SUBJECT: ISSUANCE OF AMENDMENT NOS. 55 AND 44 TO FACILITY OPERATING
LICENSE NOS. NPF-76 AND NPF-80 - SOUTH TEXAS PROJECT, UNITS 1 AND 2
(TAC NOS. M77380, M77381, M77455, AND M77456)

SOUTH TEXAS PROJECT, UNIT 1

SAFETY EVALUATION BY THE OFFICE OF NUCLEAR REACTOR REGULATION

SOUTH TEXAS PROJECT, UNITS 1 AND 2

FIGURE 3.4-2

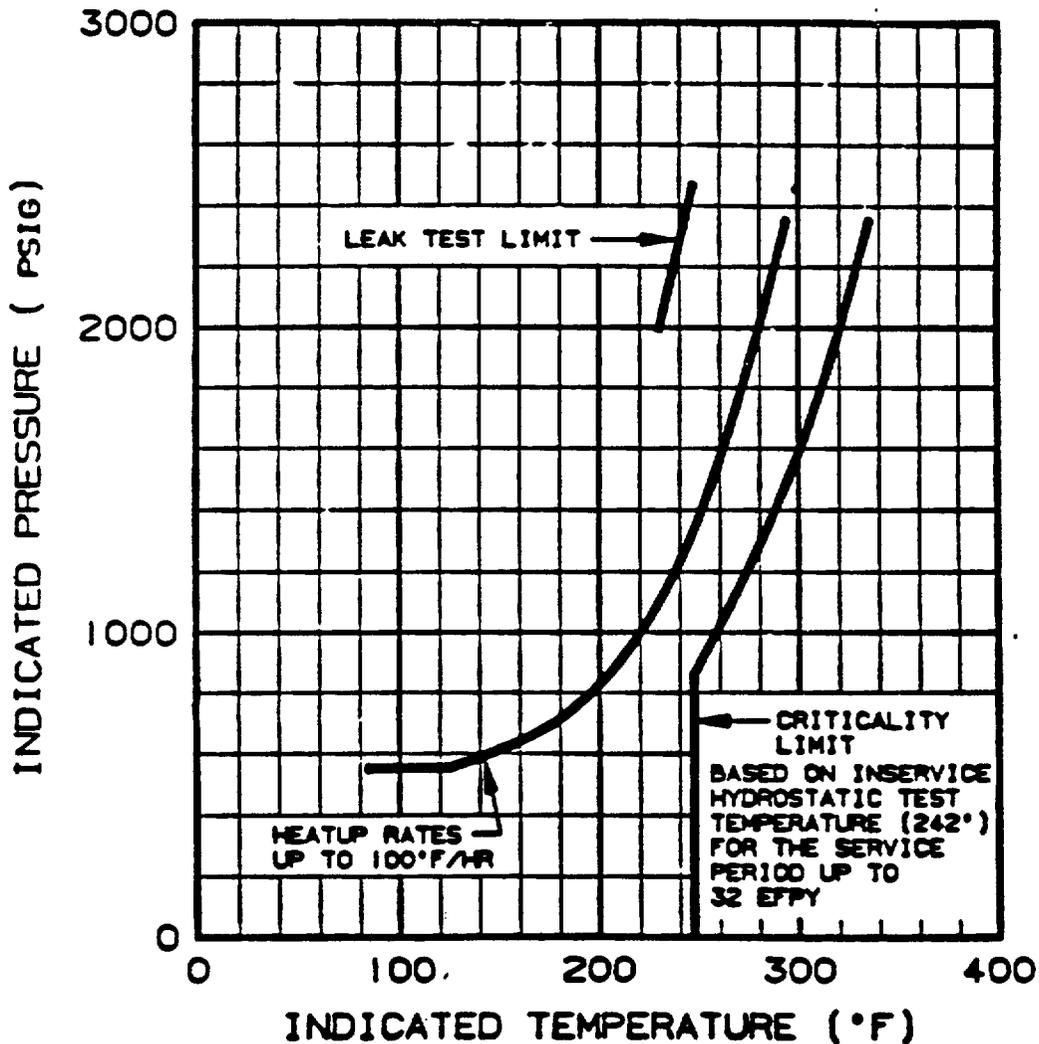
An additional revision to TS 3/4.4.9 was proposed. Technical Specification Figure 3.4-4, "Nominal Maximum Allowable PORV Setpoint for the Cold Overpressure System," is added to the figures listed in Surveillance Requirement 4.4.9.1.2 that are updated based on the results of the reactor pressure vessel (RPV) irradiation surveillance program. The change is made to emphasize the need to update the figure and the allowable PORV setpoint based on results of the RPV irradiation surveillance program. This change is acceptable.

4.4.9.1.2 The reactor vessel material irradiation surveillance specimens shall be removed and examined, to determine changes in material properties, as required by 10 CFR Part 50, Appendix H. The results of these examinations shall be used to update Figures 3.4-2, 3.4-3 and 3.4-4.
